Memorandum

Date: November 4, 2020
To: West Linn Planning Commission
From: Jennifer Arnold, Associate Planner
Subject: SUB-20-01 – 6-Lot Subdivision at 4096 Cornwall Street

Exhibit 6

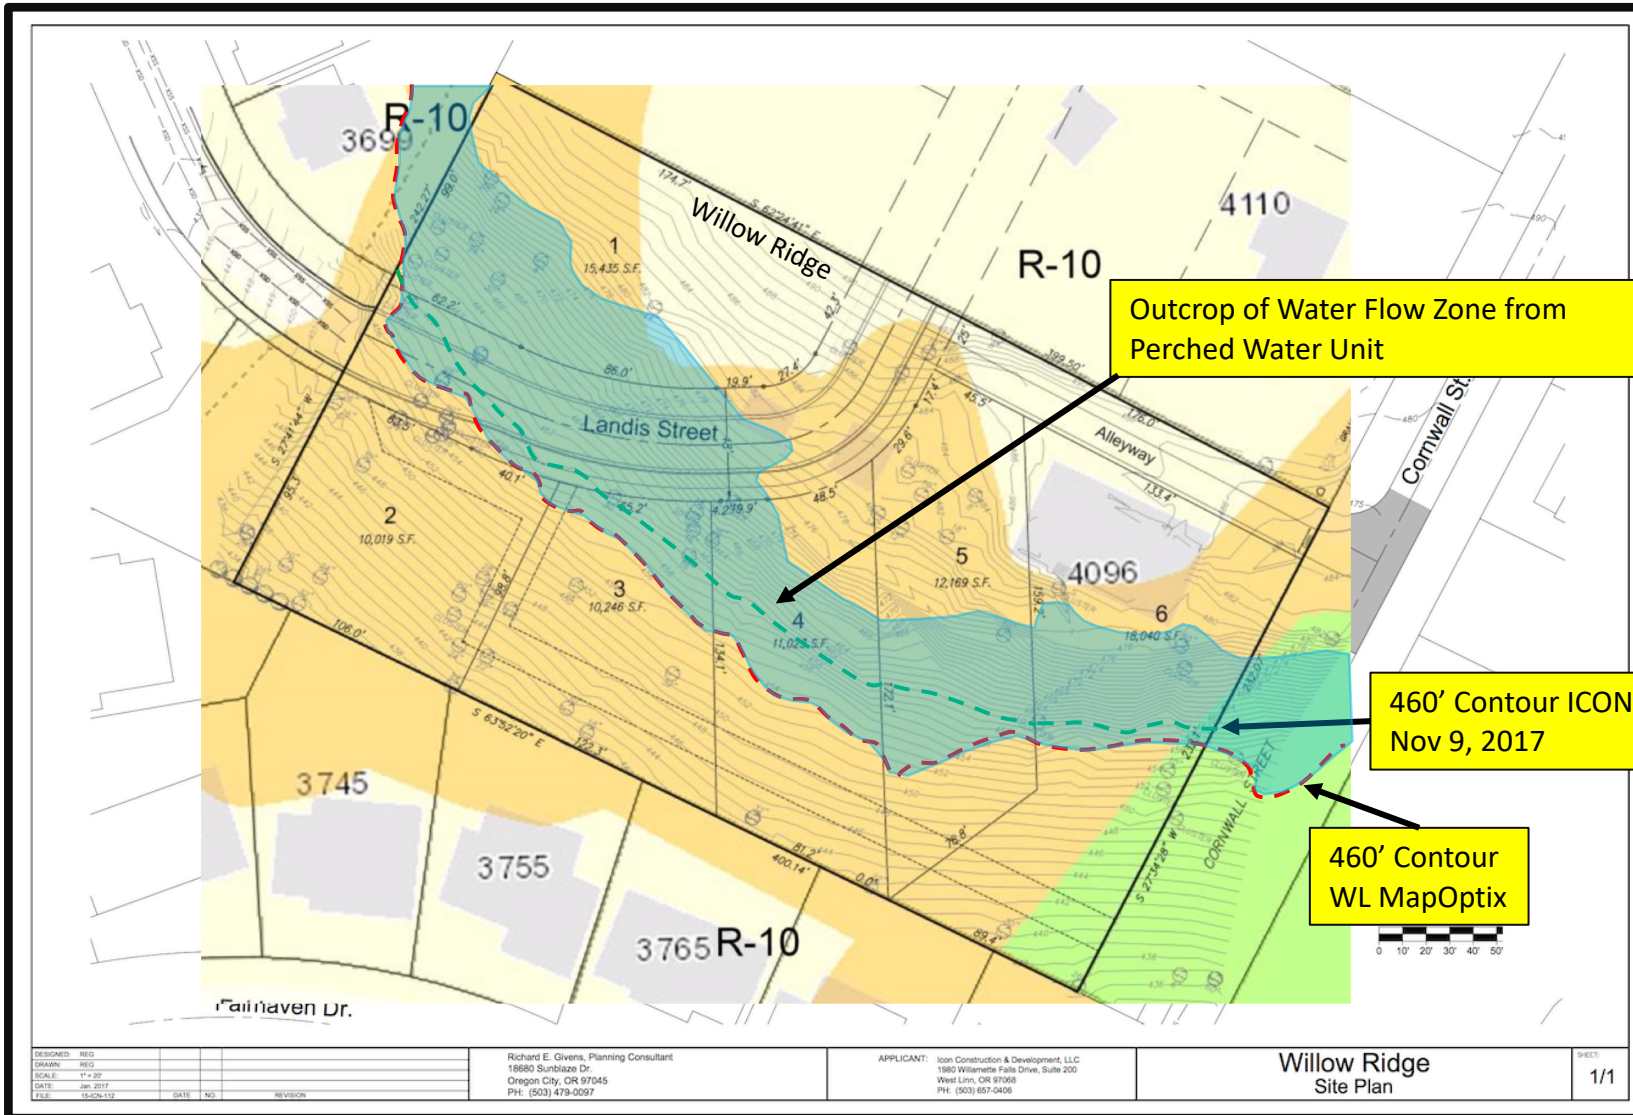
Exhibit 6 shows where the perched aquifer outcrops if the basalt layers are horizontal, as they are immediately to the east of this area.

Exhibit 8 shows where water from a new spring flooded the property of Chelsea Diaz (Public Testimony Dec. 2017). The blue is the interpreted outcrop of the perched aquifer. Evidence supporting a major change in the subsurface geology between Willow Ridge Estates and the adjacent properties a mere 100 feet away does not exist. Without additional data, a perched aquifer outcropping on the Willow Ridge slope is the most reasonable geological interpretation.

Geologic Cross Section (Profile)

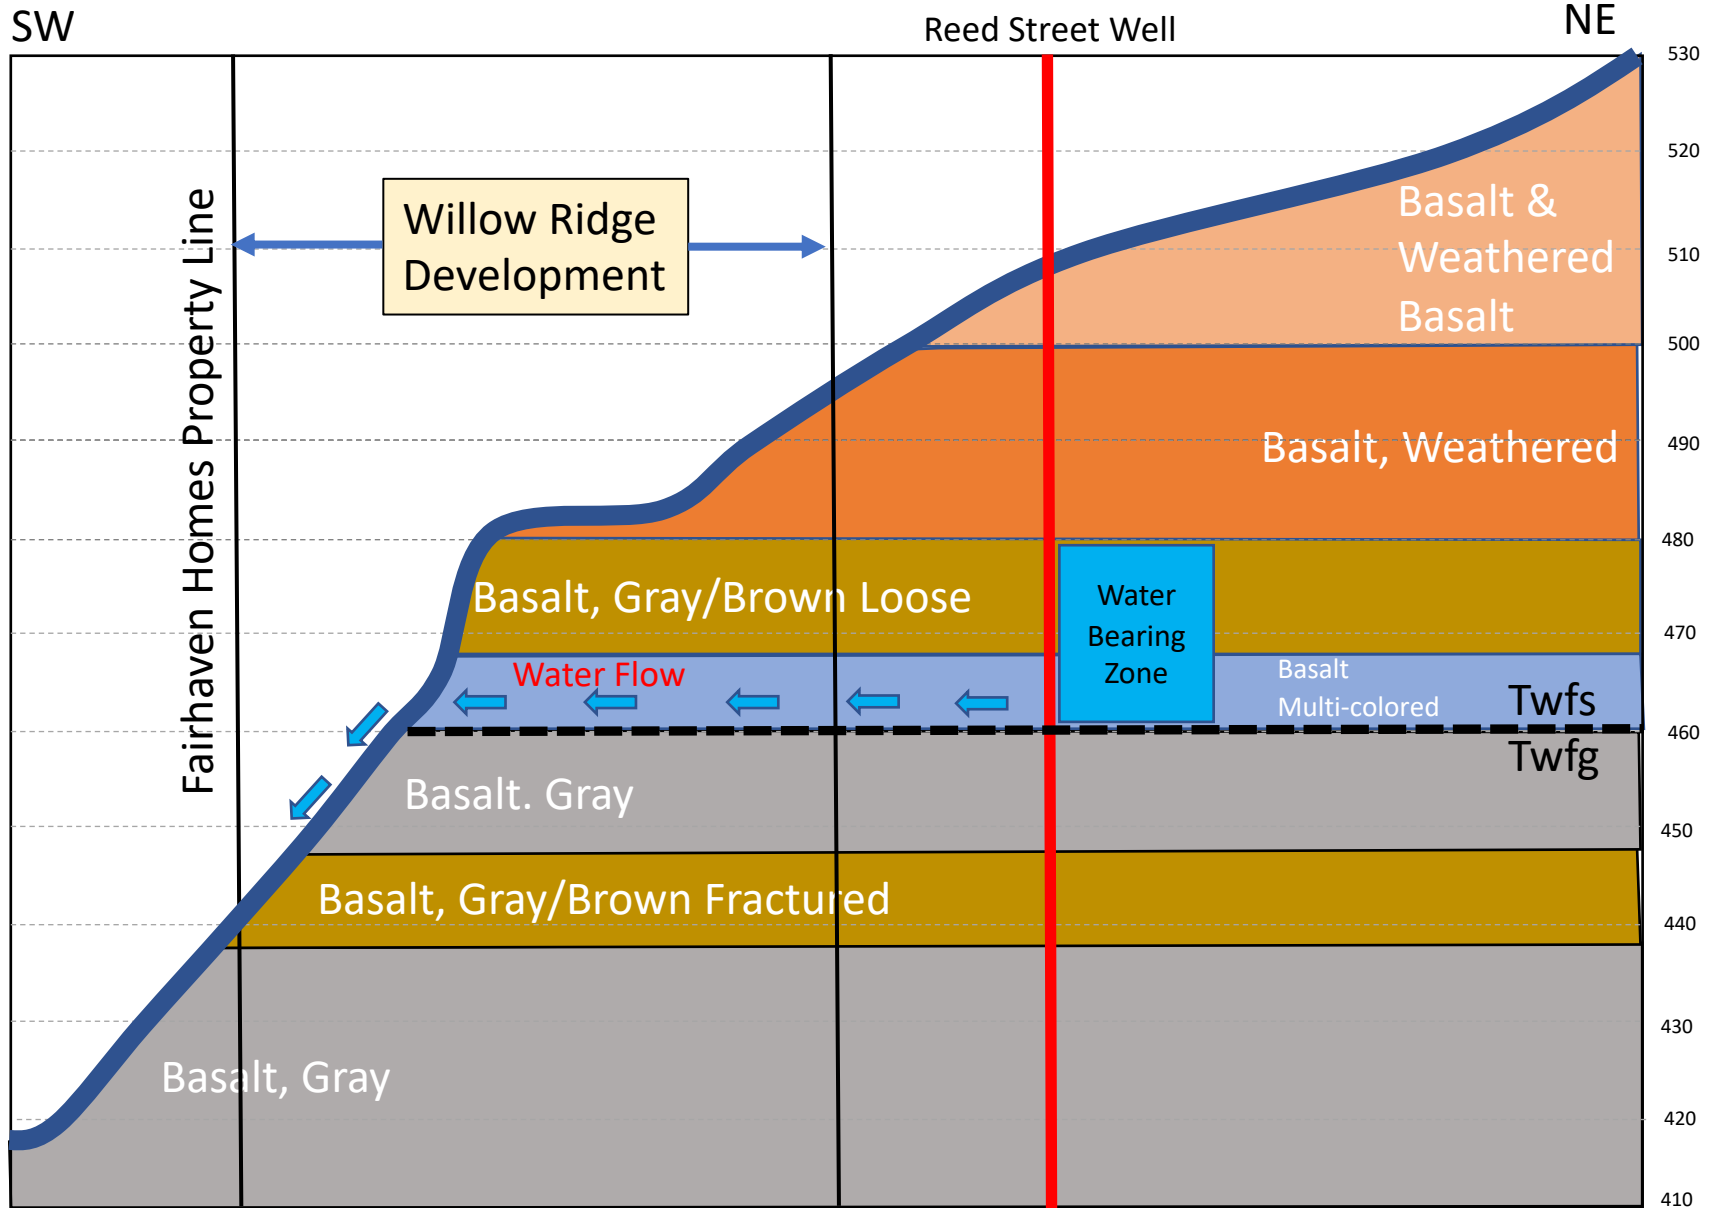
Exhibit 7 shows a geological cross-section based on horizontal strata.

The Reed Street Well is projected into the cross section based on a ground surface elevation of 508' ASL

Location map for geologic cross section

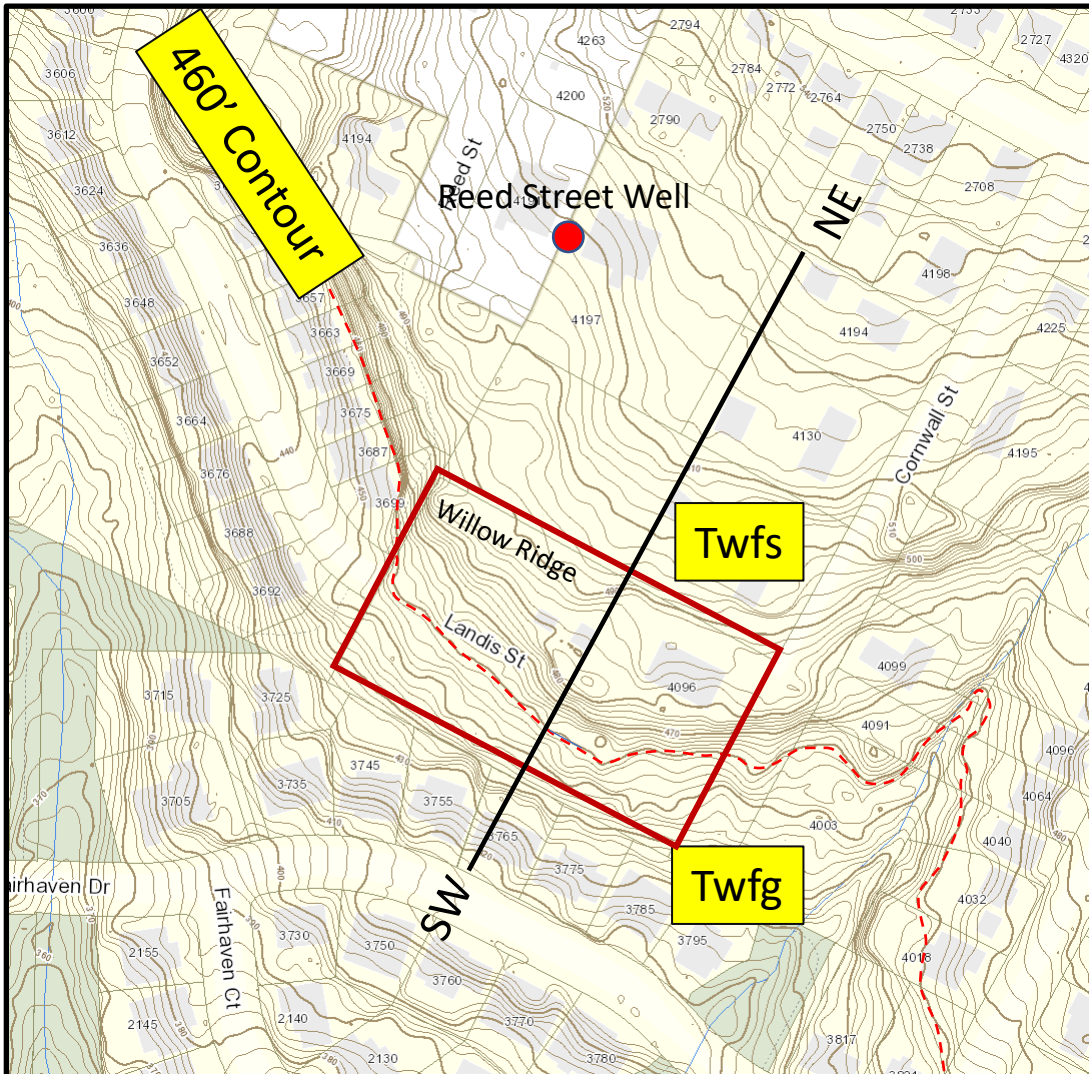
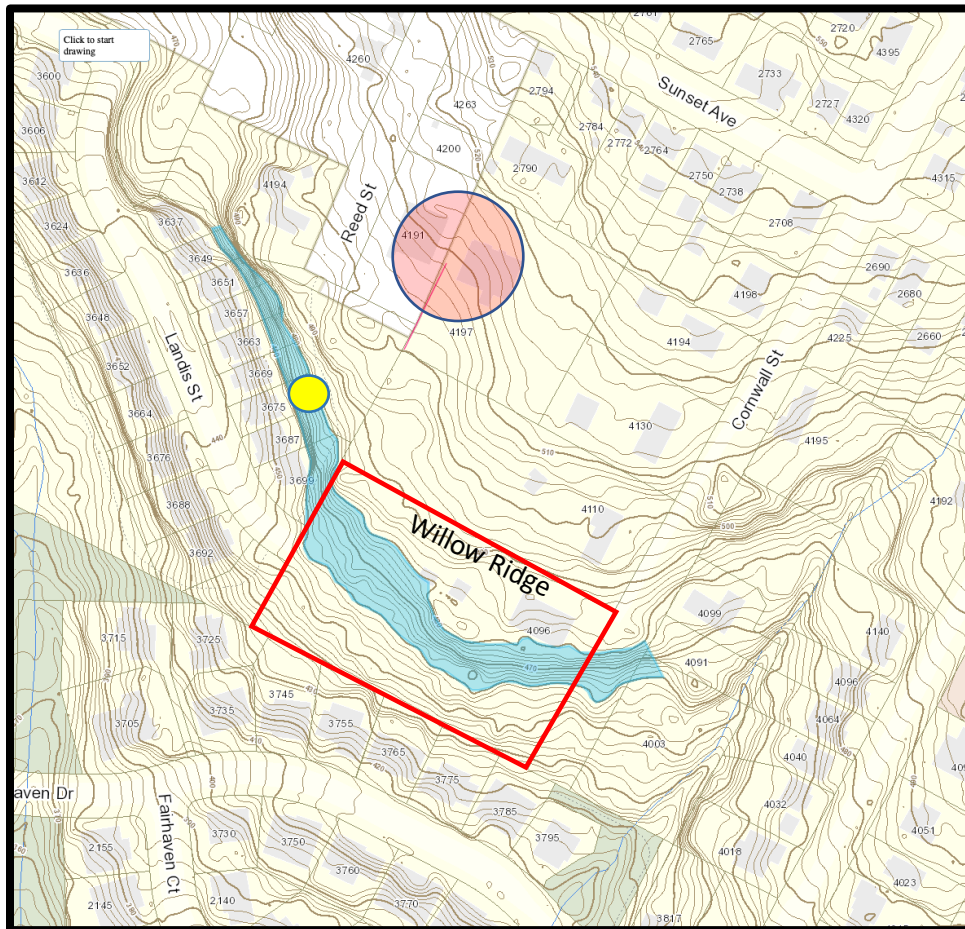
This map shows the location of a geologic cross section that runs in a NE-SW line across the center of the proposed Willow Ridge development.
